Metropolitan Water Reclamation District of Greater Chicago

December 10, 2018

SUBJECT: MWRD Permit Revision: RL 18-046
MWRD Permit No: 75-529
Name of Project: Ridgewood Court

This revision incorporates the following modifications to the work approved earlier under MWRD Permit No. 75-529:

RIDGWOOD OAKS DETENTION BASIN
TREE REMOVAL

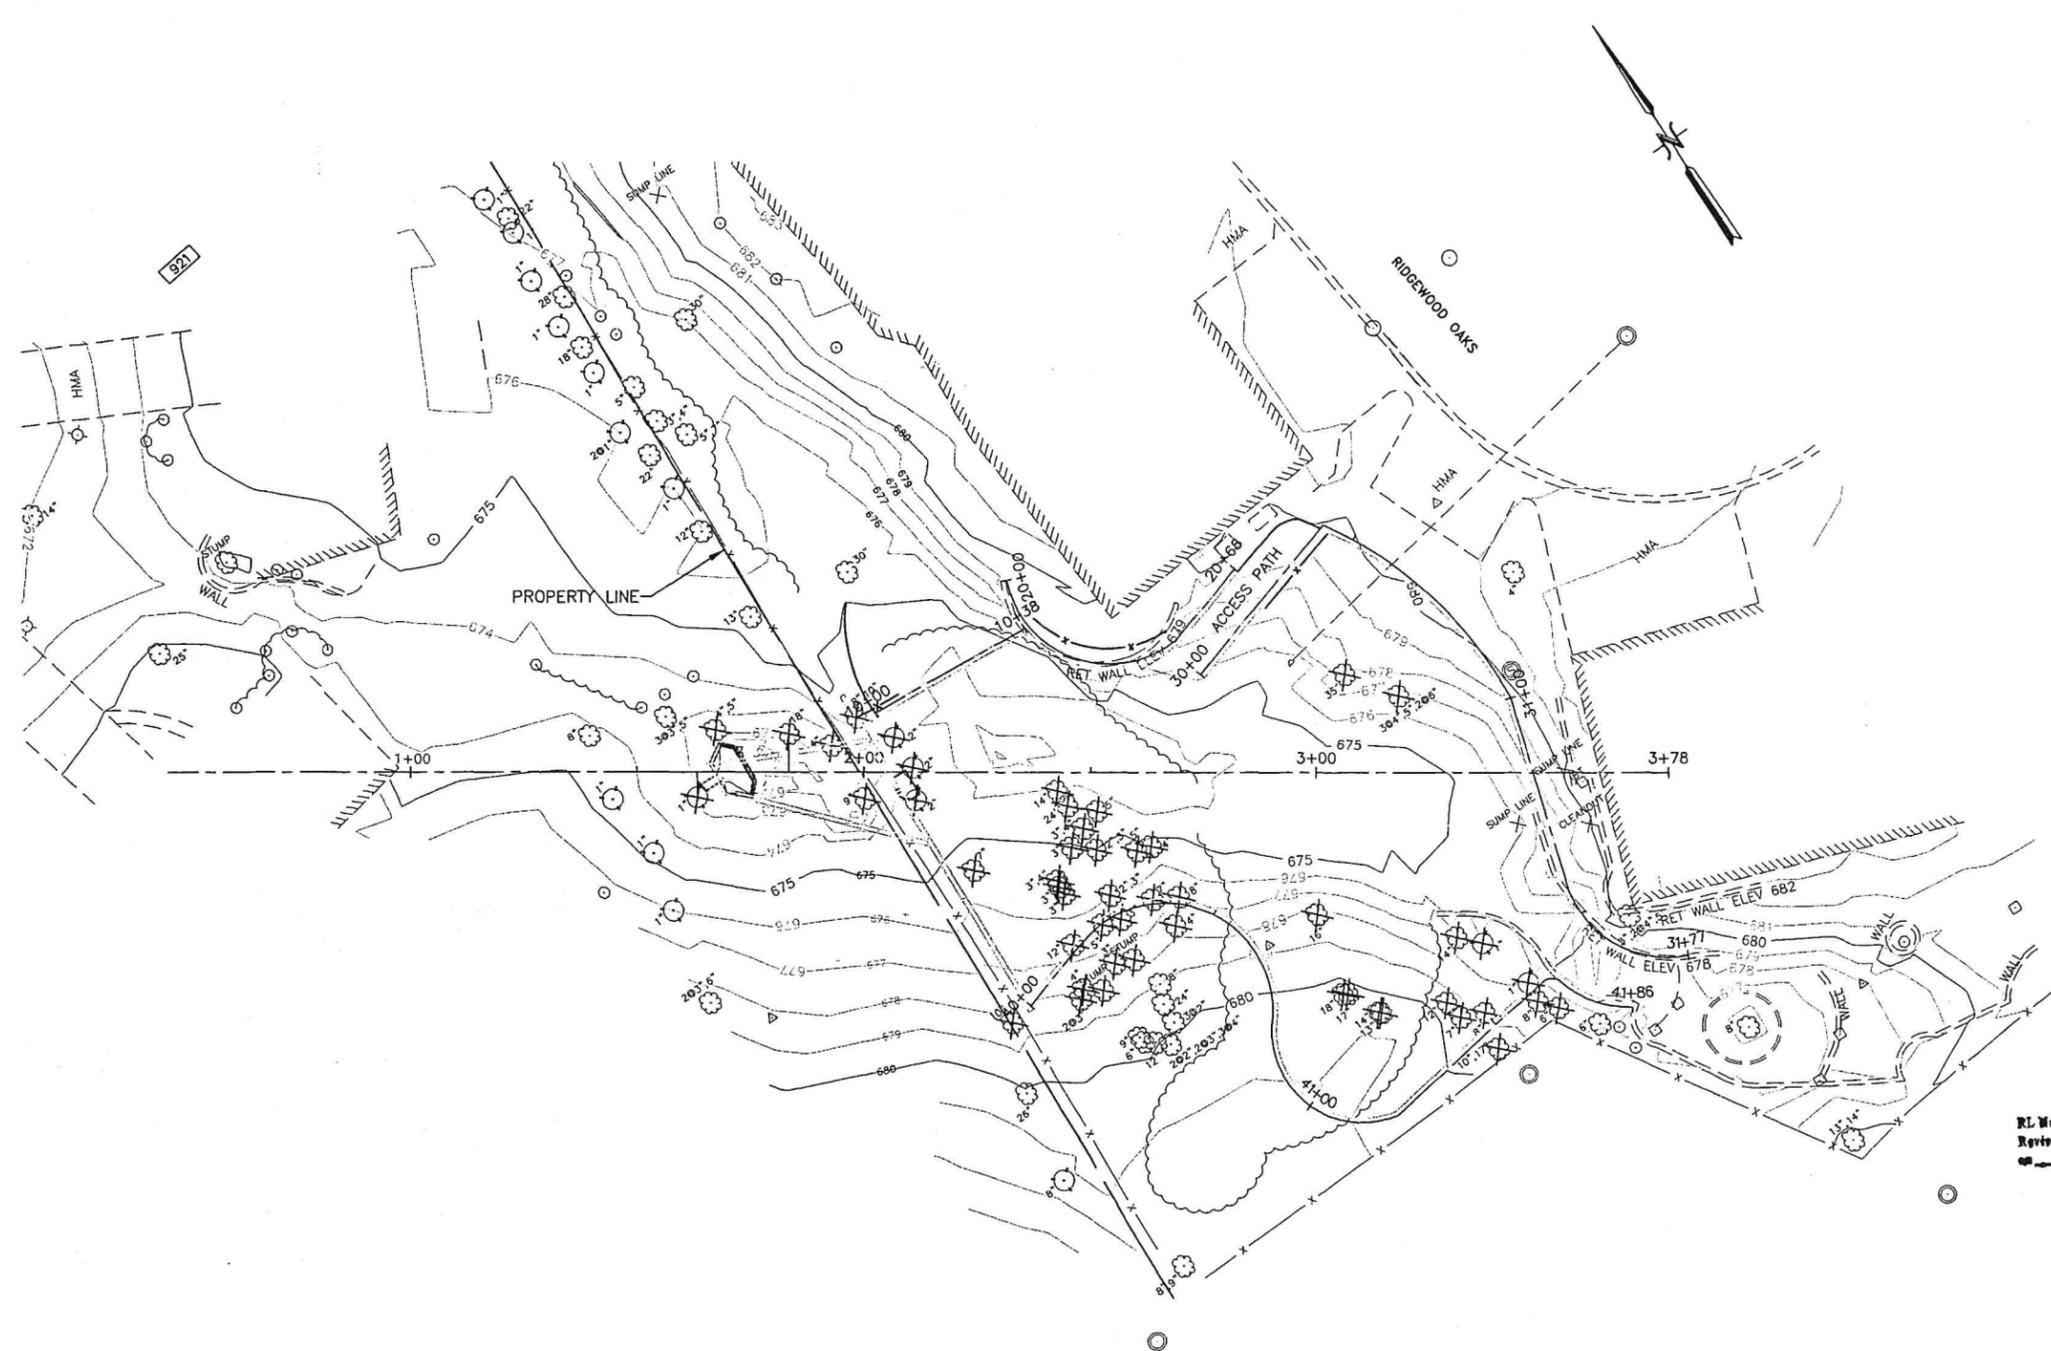
New Plans: Sheets 3, 4; Dated 10/4/2018
Sheet 5; Dated 11/20/2018

1. The existing stormwater detention facilities constructed under the original permit are now revised and are financed by the Village.
2. Schedule A is now revised to reflect the changes to the detention basin.
3. Schedule D and the stormwater detention calculations are now revised to the following:
 - i. The volume provided (0.60 ac-ft) exceeds the required volume (0.59 ac-ft).
 - ii. The HWL elevation is 675.00 and the NWL elevation is 670.00.
 - iii. The existing restrictor is replaced with a 6 inch diameter orifice plate.

SECTION VIEWS AND
STRUCTURE AND WALL IDENTIFICATION MAP

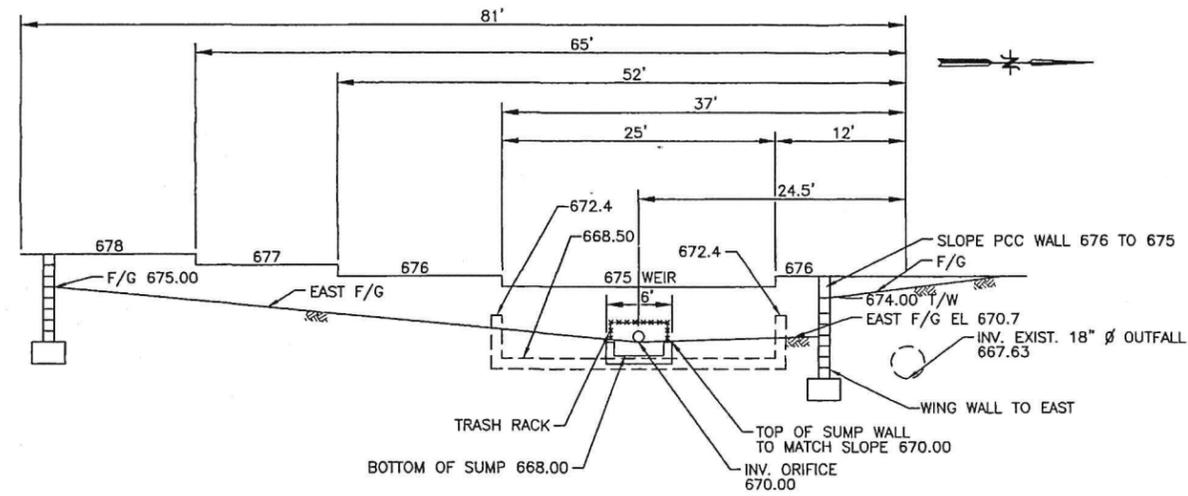
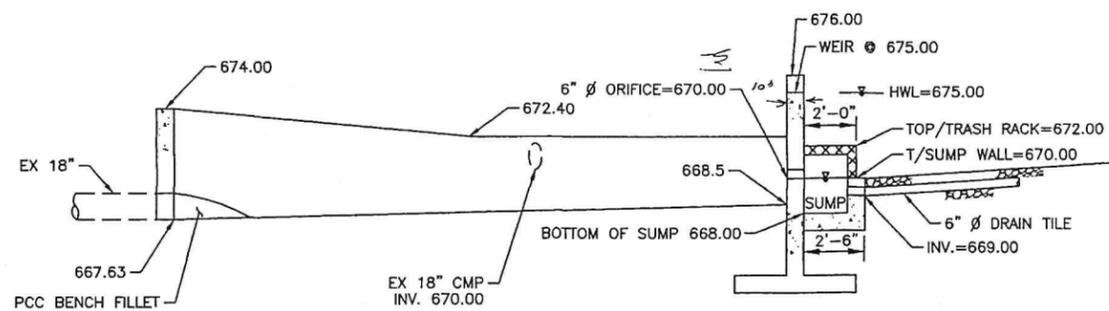
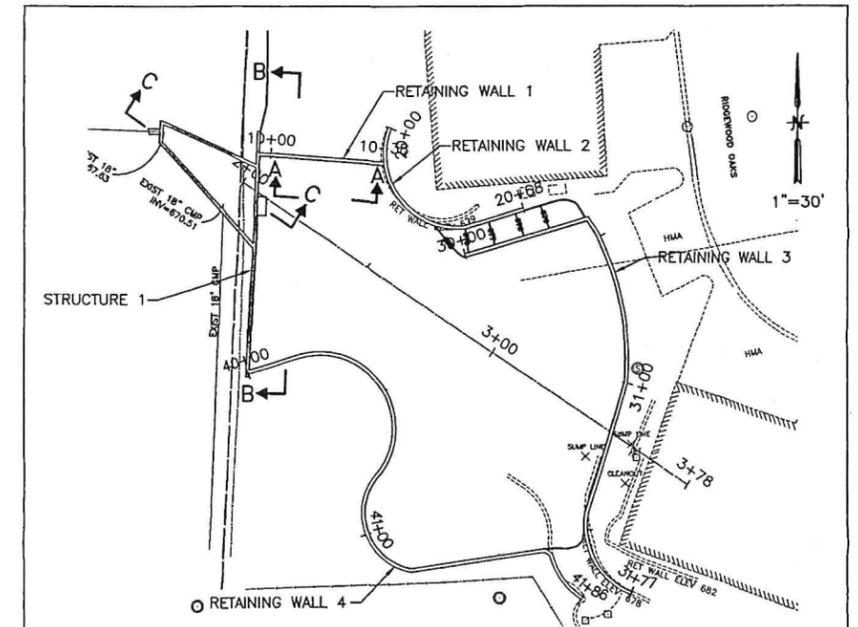
- iv. The actual release rate (2.09 cfs) is less than the allowable release rate (2.18 cfs).
- 2. Page 8 and page 9 are now executed by the Village of Western Springs and Ridgewood Oaks Homeowners Association, and are made a part of the permit.
- 4. There is no change to the sanitary sewer system approved under the original permit.

- 5 (R). The stormwater detention calculations and facilities under the permit revision supersedes those covered under MWRD Permit No. 75-529. Stormwater detention is provided by detention basin with a 6 inch diameter orifice restrictor.
